**DOCKET NUMBER 50-483
CALLAWAY PLANT
UNION ELECTRIC COMPANY
RESPONSE TO REQUEST FOR ADDITIONAL INFORMATION
ON REVISION TO TECHNICAL SPECIFICATION 5.5.9
"STEAM GENERATOR (SG) TUBE SURVEILLANCE PROGRAM"**

**REQUEST FOR ADDITIONAL INFORMATION
REVIEW OF THE CALLAWAY PLANT APPLICATION
FOR REVISION TO TECHNICAL SPECIFICATION 3/4.4
TAC NUMBER: MB1214**

Figure R30-12

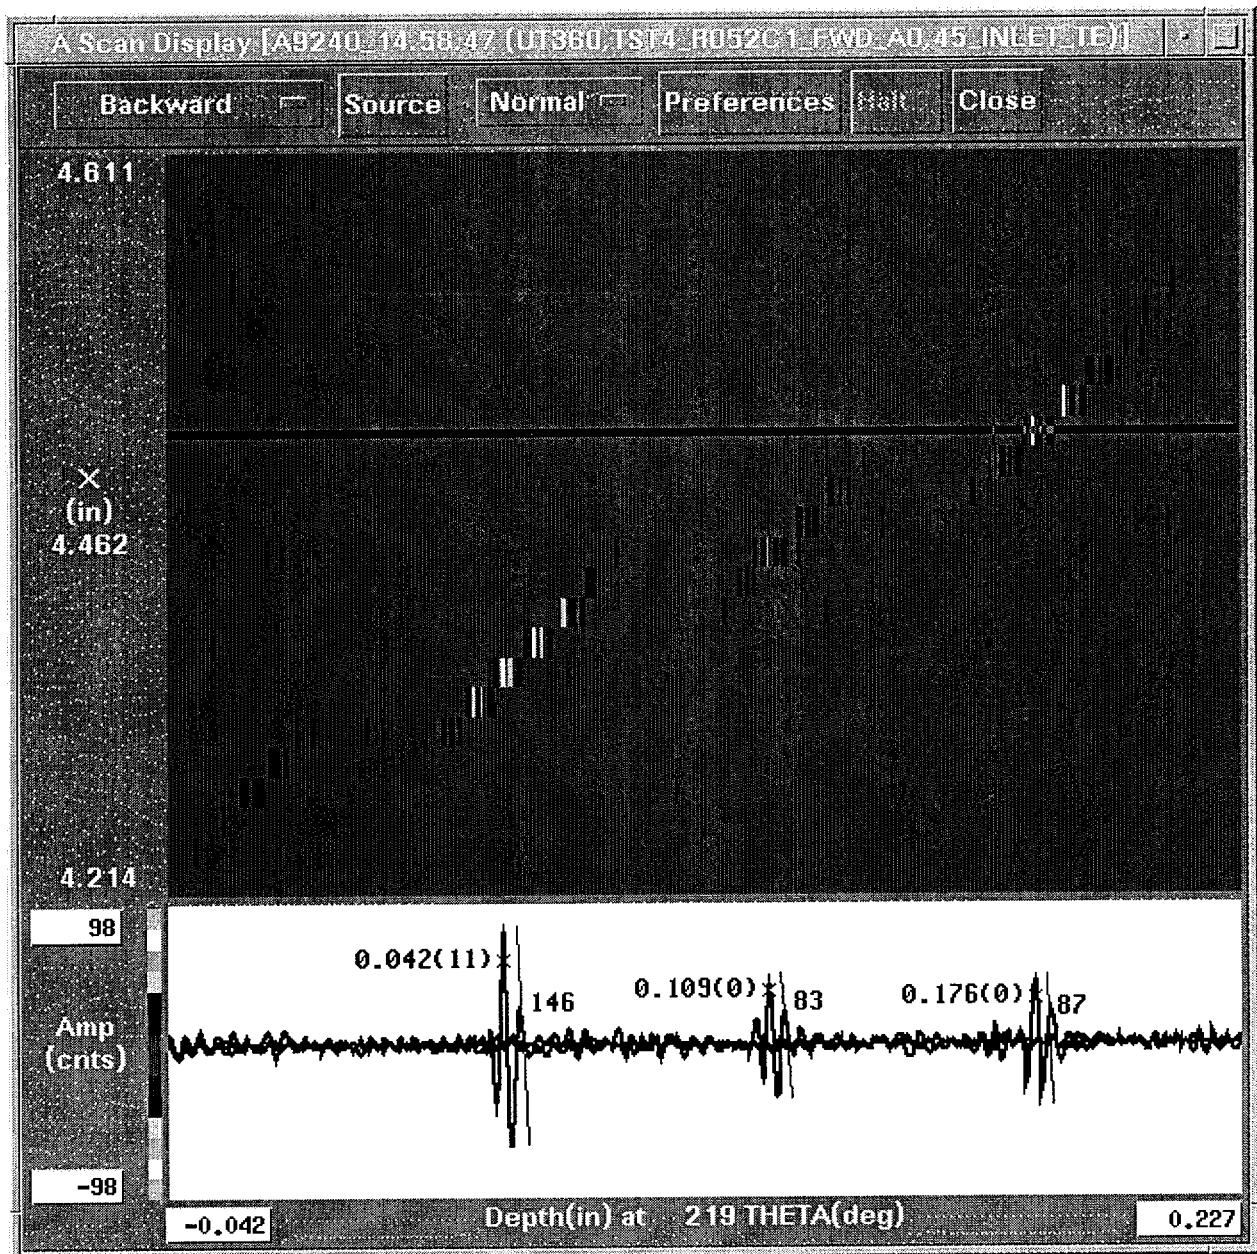
RAI # 30. The report states that “UT techniques have been shown to be effective in the detection and sizing of fatigue cracks propagated into the sleeve material.” Please provide data to support this assertion. (Page 11-57, BAW-10219P, Rev. 4)

This is the pre-fatigue crack C-Scan plot of the ODSCC circumferential crack in tube TST4-072-1. The crack extent (length) can be estimated from the C-Scan plot as $(278 - 85)$ or 193 degrees. The plot shows the presence of a half skip response, a one and one half skip response and some full skip reflections.

This is the post-fatigue crack C-Scan plot of the ODSCC circumferential crack in tube TST4-072-1. The crack extent (length) can be estimated from the C-Scan plot as $(275 - 80)$ or 195 degrees. The fatigue cycling has not significantly increased the crack extent (length). The plot shows the presence of a half skip response, a one and one half skip response and an increase in the full skip response.

This is the pre-fatigue crack C-Scan plot of the ODSCC circumferential crack in tube TST4-052-1. The crack extent (length) can be estimated from the C-Scan plot as $(280 - 70)$ or 210 degrees. The plot shows the presence of a half skip response, a one and one half skip response and some full skip reflections between the 148 degree and 234 degree locations along the crack extent.

This is the post fatigue crack C-Scan plot of the ODSCC circumferential crack in tube TST4-052-1. The crack extent (length) can be estimated from the C-Scan plot as (280 – 70) or 210 degrees. The plot shows the presence of a half skip response, a one and one half skip response and an increase in the full skip response between the 200 degree and 230 degree locations along the crack extent.

This is the post final deposition C-Scan plot of the ODSCC circumferential crack in tube TST4-052-1. The crack extent (length) can be estimated from the C-Scan plot as (275 – 70) or 205 degrees. The plot shows the presence of a half skip response, a one and one half skip response and the diminished amplitude of the full skip response.
